YARRA CITY COUNCIL
Internal Development Approvals Committee
Agenda – Part 2 of 2

Item		Page	Rec. Page
1.4	271 Bridge Road, 208, 224, 228, 230, and 238 Church Street, 42 and 46 Cameron Street and 25 and 37 - 39 Bank Street Richmond - PLN11/0834.03 - Section 72 Amendment to allow for changes to the permit preamble, conditions of the permit and changes to the endorsed plans including reconfiguration of uses, changes to car parking and bicycle provisions and built form changes.	5	100

1. This report provides Council with an assessment of planning application PLN11/0834.03 being an amendment to the approved development of the former Richmond Plaza site at 271 Bridge Road, 208, 224, 228, 230 and 238 Church Street, 42 and 26 Cameron Street and 25 and 37 – 39 Bank Street, Richmond and recommends approval subject to conditions.

North and West Elevation of Building D - Amended Plans

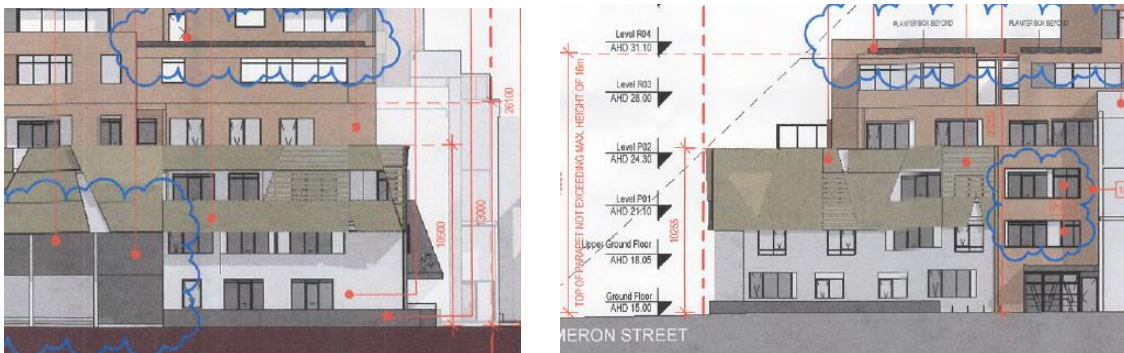
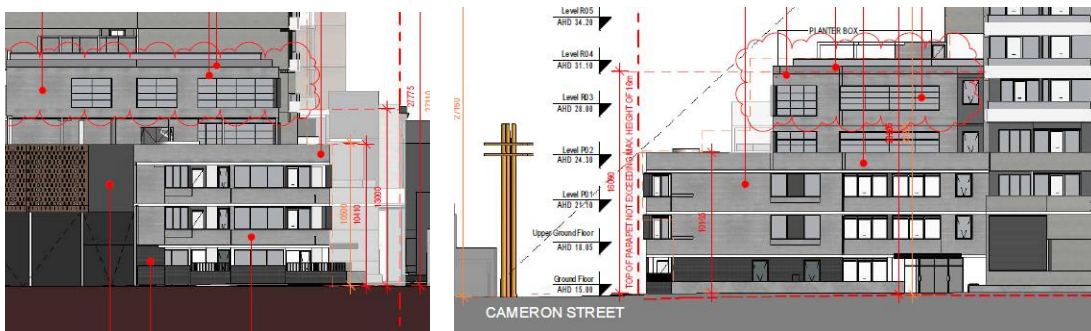
200. The image below outlines the endorsed plans for the portion of the site applicable to 42 Cameron Street which is included within the General Residential Zone 2 with a maximum height of 9m. The current endorsed plans show:

201. In comparison, the proposed amendment can be described as the following:

202. In a general sense the envelope of the endorsed and that of the proposed amendment are comparable albeit a lesser setback is proposed at ground level. It is suggested to seek to reduce the scale or to address a garden area requirement as per the zone requirements would undermine the strategic importance of the broader site.

Proposed Building A - Elevation

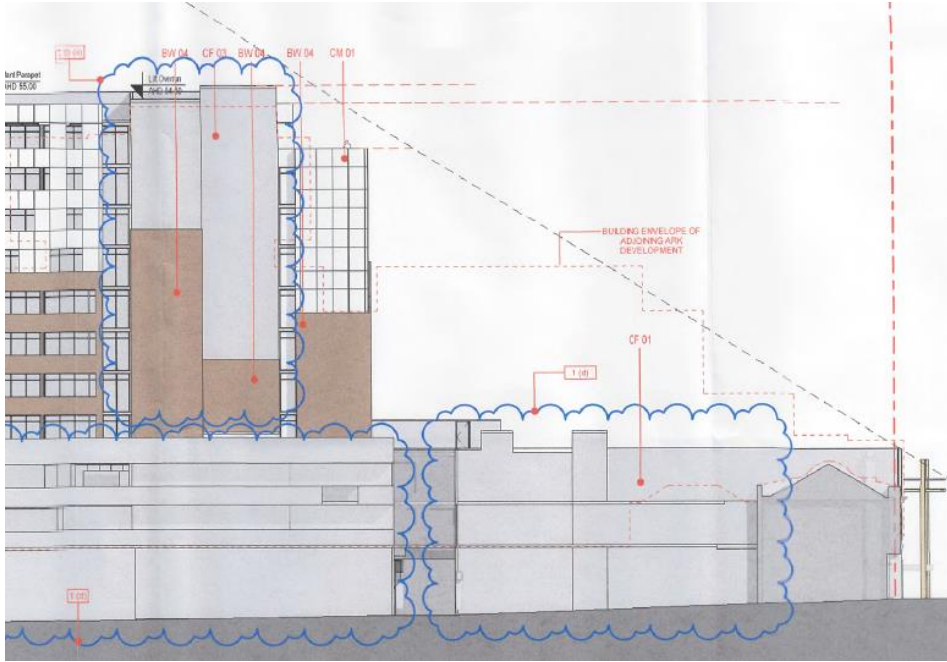
- 227. The proposed composition of Building A seeks to refine this elevation with finer vertical details extruded up the building. The vertical fins which run down the face of the building are detailed in a waterfall pattern which are horizontally divided at various heights across the face of the building.
- 228. Colour variation is still proposed but this is expressed horizontally with a red brick base, red brick colour oxide for the midrise section and a lighter off white colour for the upper most levels.

Endorsed Plan – West Elevation

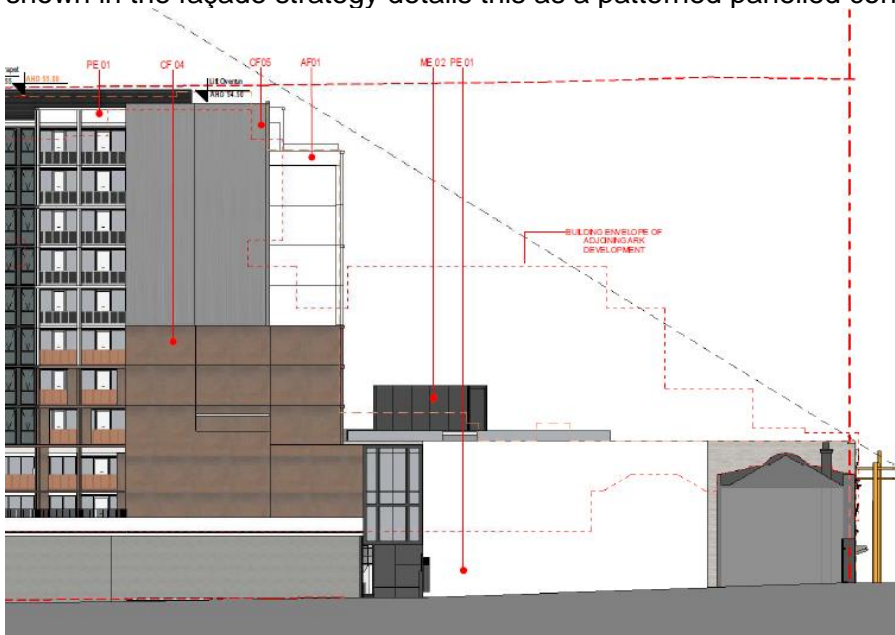
- 230. Councils urban designer raised no issues with the modified treatment of the upper level of Building A, however did require more clarity around the materiality of the building and required additional thumb nail sketches to ensure the detailing of the building is correctly shown on plan, these were included within the application material and officers are satisfied that subject to conditions this presentation is acceptable.
- 231. The prominence of the lift core and its treatment from both the west and Bridge Road elevations, has always been an element which requires careful consideration.
- 232. The endorsed plans show to the west a combination of red brick and concrete finish in an irregular pattern.

- 233. The proposed amendment elevation also shows a prominent lift core area treated in a patterned off white concrete finish with the lower level treated in the red brick oxide. The plan shows this as a primarily blank wall as shown in the image below, however greater details shown in the façade strategy details this as a patterned panelled concrete wall.

Proposed – Design details for Building B

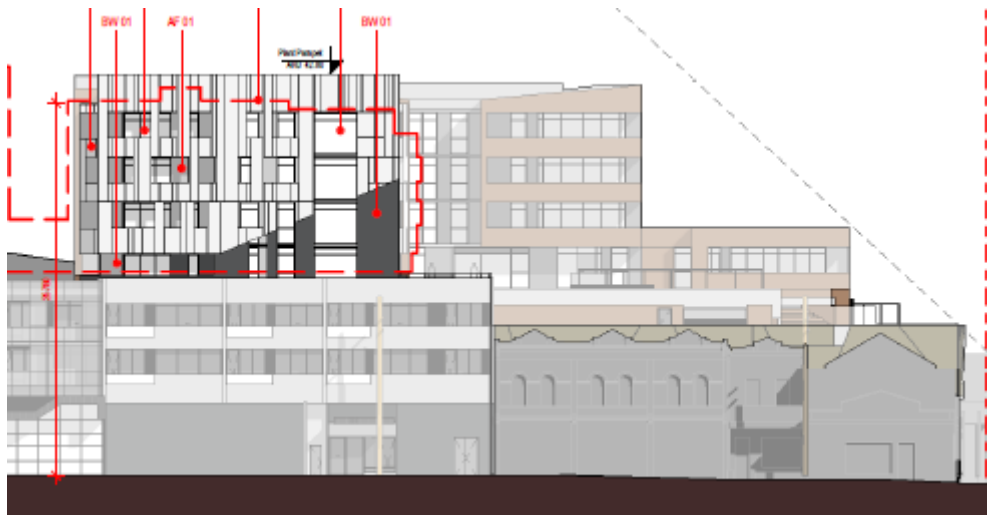
265. The façade strategy as depicted in the 3D image detail a well resolved building to the street. Conditions will require consistency between the montages and elevations to ensure the quality of built form.

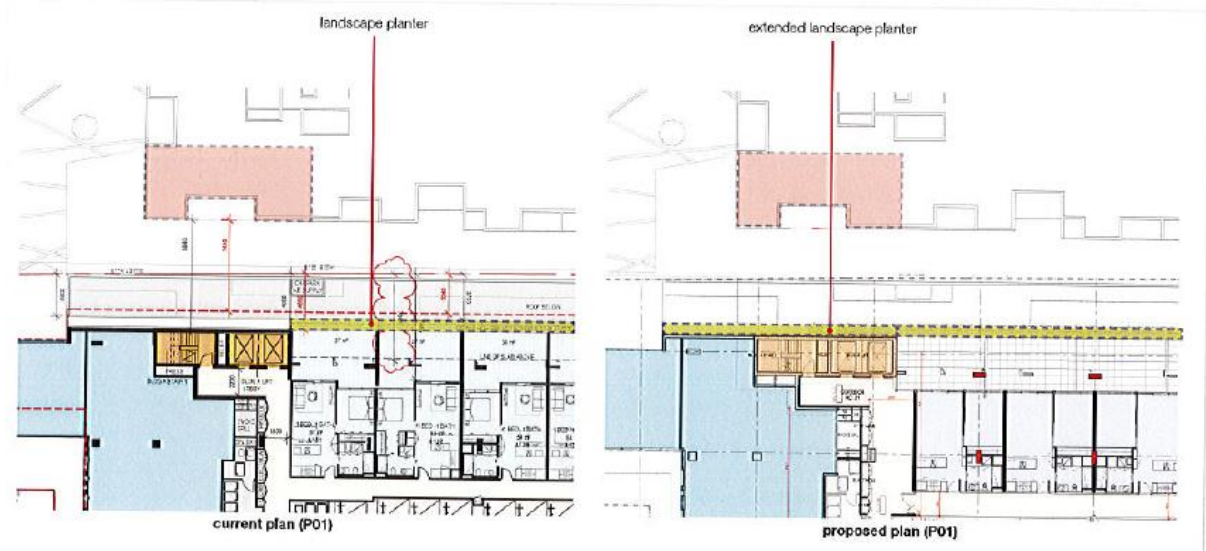
(g) *Vehicle laneway off Bank Street and Cameron Street be constructed with sawn bluestone to provide consistency.*

Comment: - Officers agree that this area should be treated in bluestone as currently shown on the endorsed plan

Proposed schematic Plan showing climbing plants

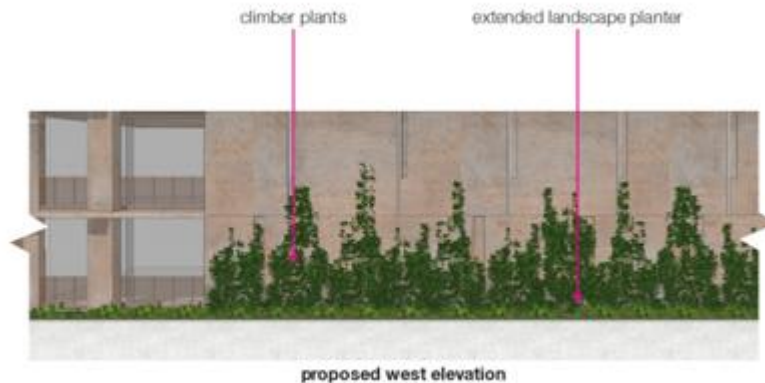
293. Schematic plans also submitted by the permit applicant (dated 24 March 2020) responding to concerns raised in an objection regarding outlook from an apartment in Ark seek to increase the perimeter landscape strip along the western boundary along the core and office tenancy at Level 1.

294. It is considered that this minor change can readily be accommodated as depicted in the images about and should form a condition of the landscape plan.

Figure 19: Section through building A (proposed) and ARK (TP-30, Revision 1)

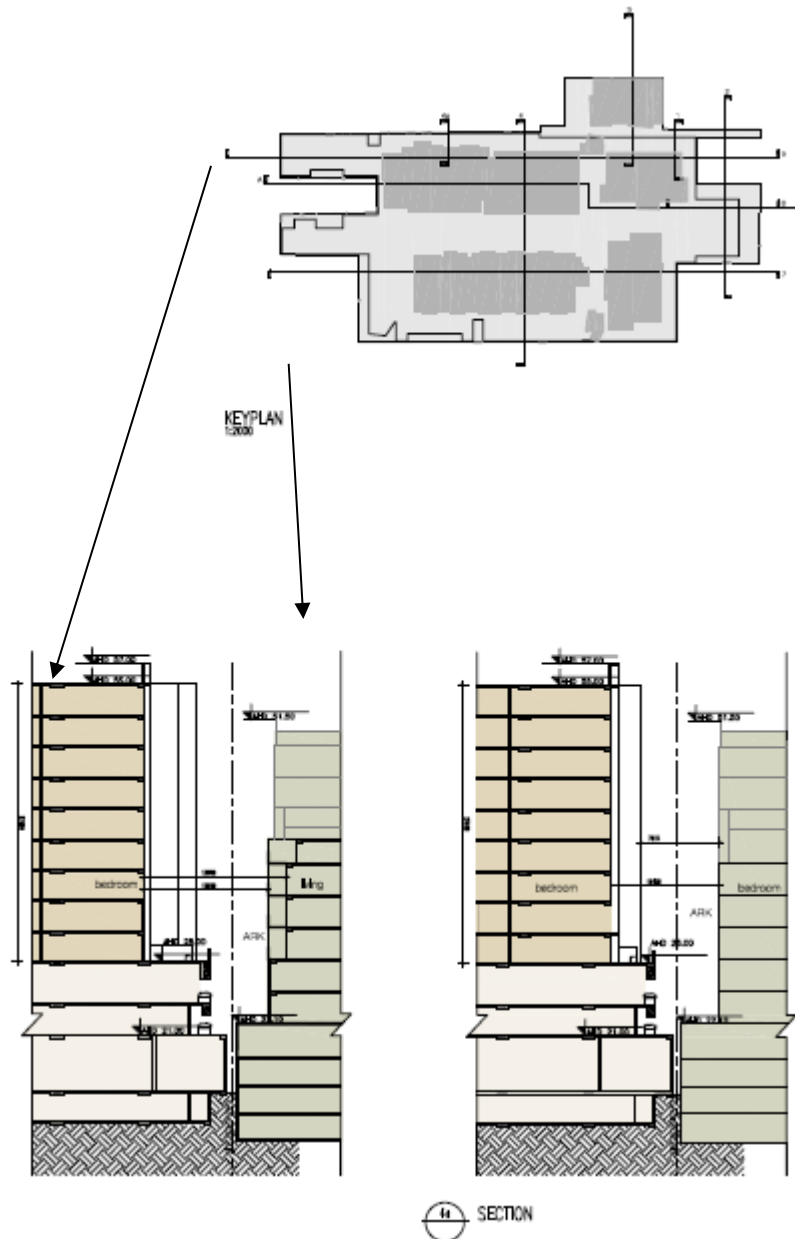
'To the south-west, the ARK development has adopted a podium and tower configuration, being the same typology as is proposed in this instance. The proposal has considered the impact on the adjacent site through a three storey podium and 3.3m to 8.6m tower setbacks from the west title boundary.'

It has been established that a 4.5m side boundary setback was envisaged by VCAT for the ARK development and any future development of the Richmond Plaza site. This would ensure a reasonable separation between towers so that residents could enjoy reasonable daylight levels without the need for extensive screening (preventing overlooking). In this instance, apart from the lift core with a 3.3m west boundary setback, the development has offered setbacks exceeding the minimum 4.5m approach.

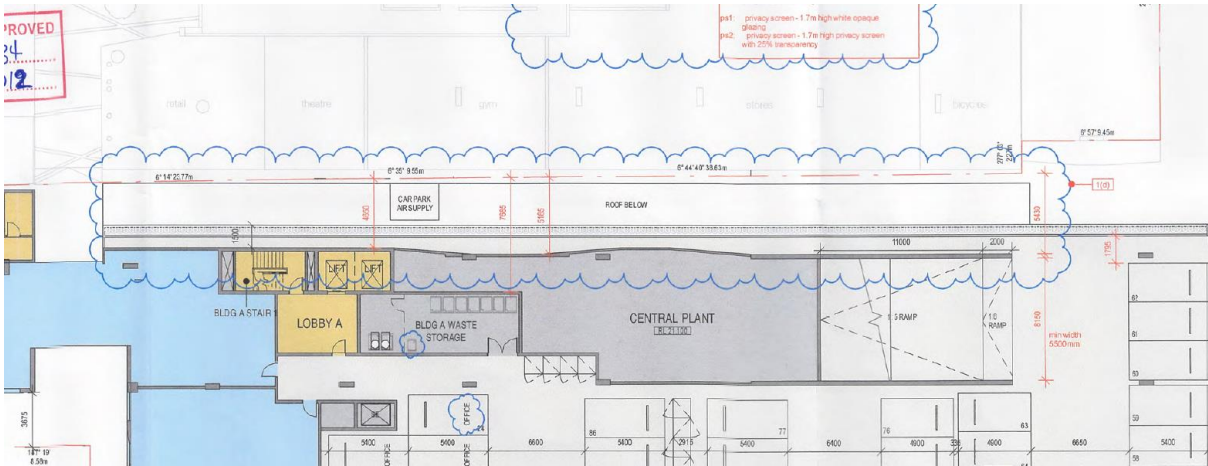
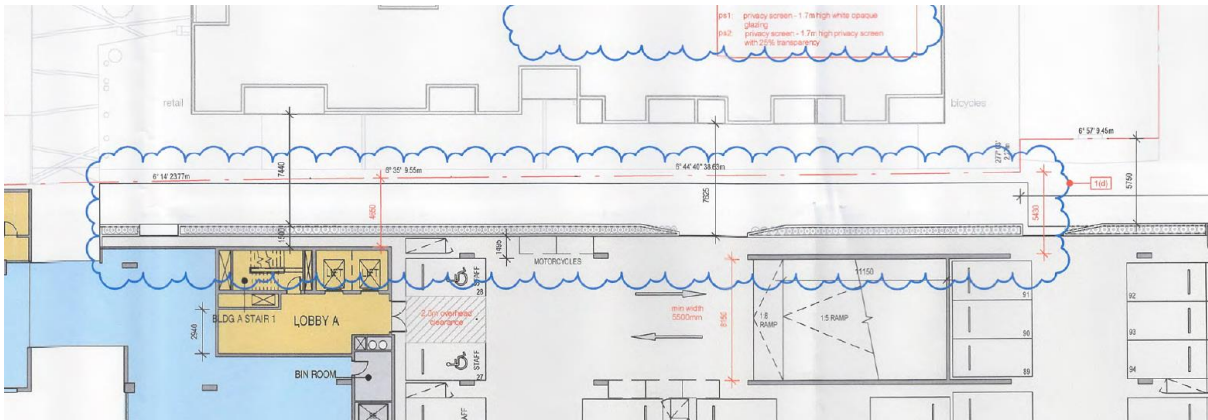
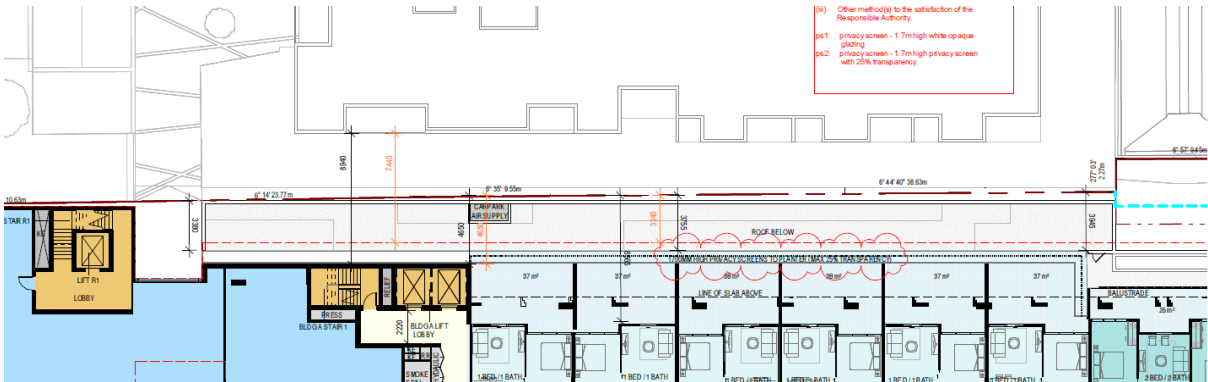
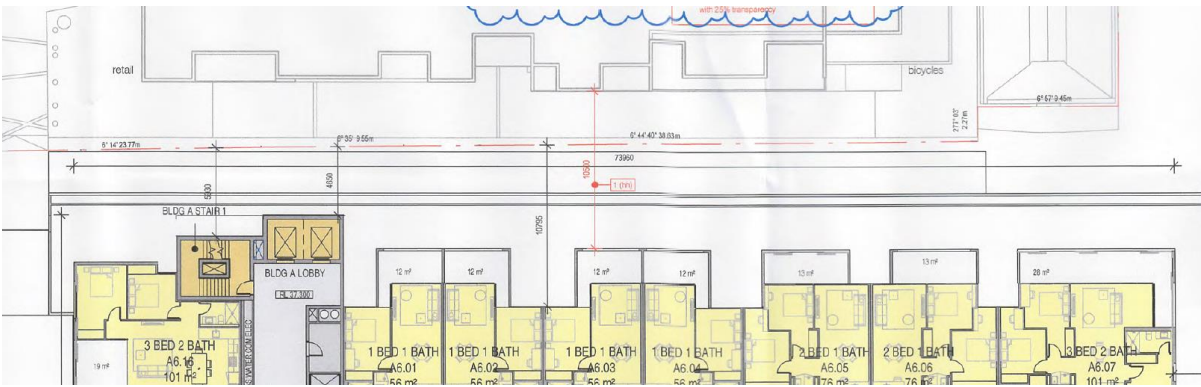
377. As endorsed, the interface with the Ark at Level 1 shows a separation distance from the boundary of between 3.1m to planter edge increasing to 4.5m. This increases at level 2 where the current plans show a separation distance of between 7.4 - 7.6m to car park edge with a landscape planter projecting into this setback. The setback to the stair and lift core increased the separation by another 1.5m

378. The setbacks proposed by the amendment seeks to increase the minimum setback to the boundary is 3.7m with deep terrace areas interfacing at this level. This separation distance moderately improves the interface with Ark while providing an acceptable level of amenity to the new row of apartments. The separation distance between apartments is approximately 8.9m.

380. At Level 2 the separation distances increase to vary between 8.9 – 10.6m which is an improvement to the existing setback levels and affords a good level of amenity to the proposed new apartments.

379. As discussed earlier, through discussions with an objector owner of an apartment in ARK, the proposed landscaping strip proposed at the balcony edges will be extended to along the core and office area. A condition on any permit granted will require this change.

Southern interface – Podium levels

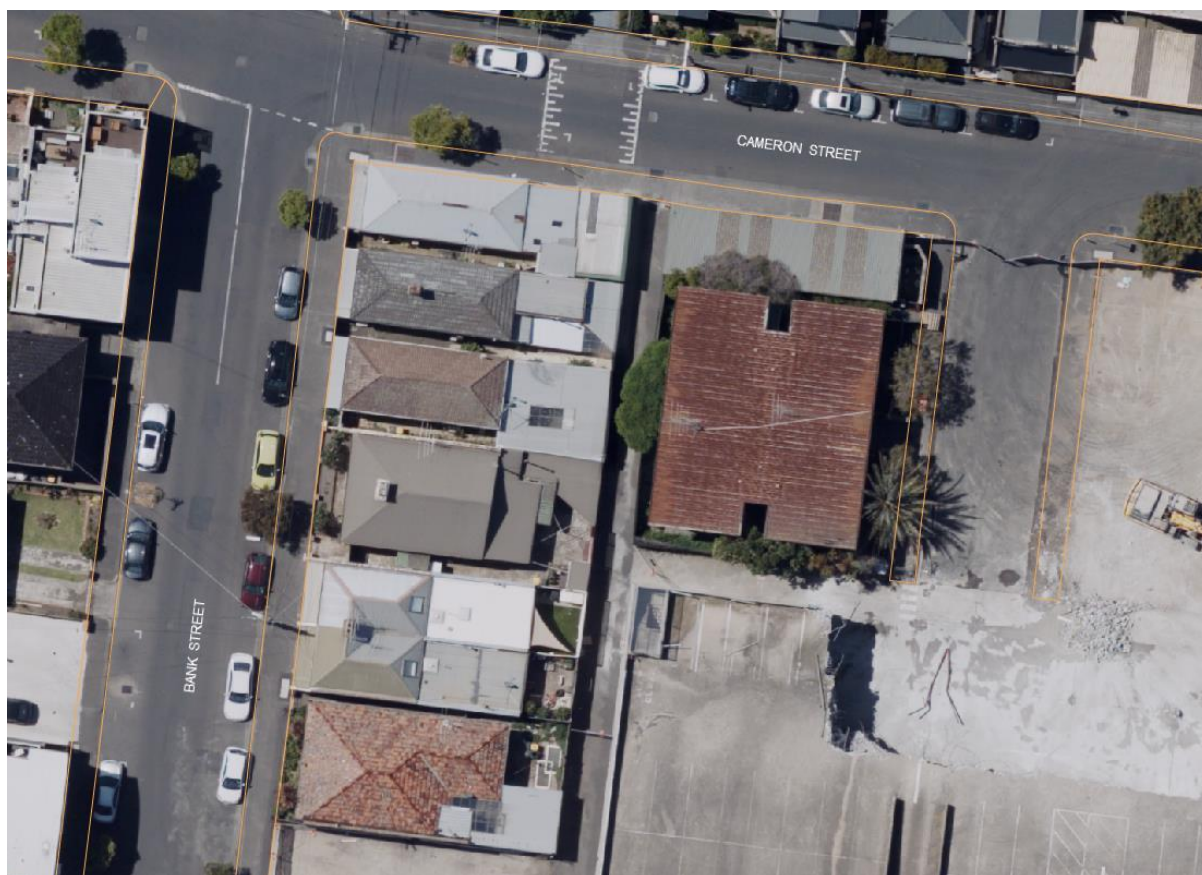
389. The southern interface with the subject site is the individually significant former bank building at 267 Bridge Road. At the first floor is a centrally located terrace which wraps around part of the site extending along the eastern boundary.

390. Previously the endorsed plans show a 2.4 metre setback at both levels 1 & 2, this is proposed to be reduced by 100mm at level 2. This change is considered to be inconsequential to the application.

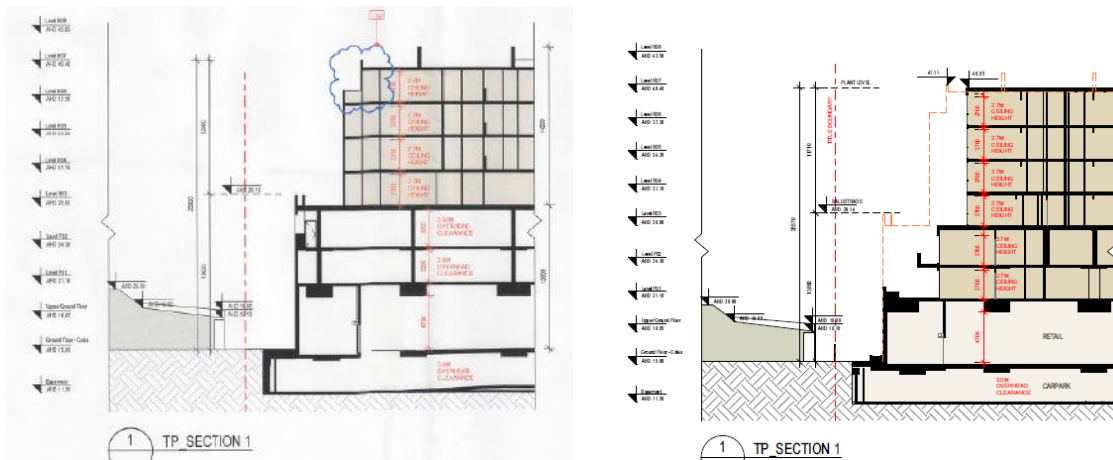
393. Separating the Bank Street residences and the subject site is a 3m wide ROW. The setbacks from the ROW for both the endorsed and proposed are described in the table below

394. The setbacks adopted by the amendment are mostly comparable with those endorsed however with some increases.
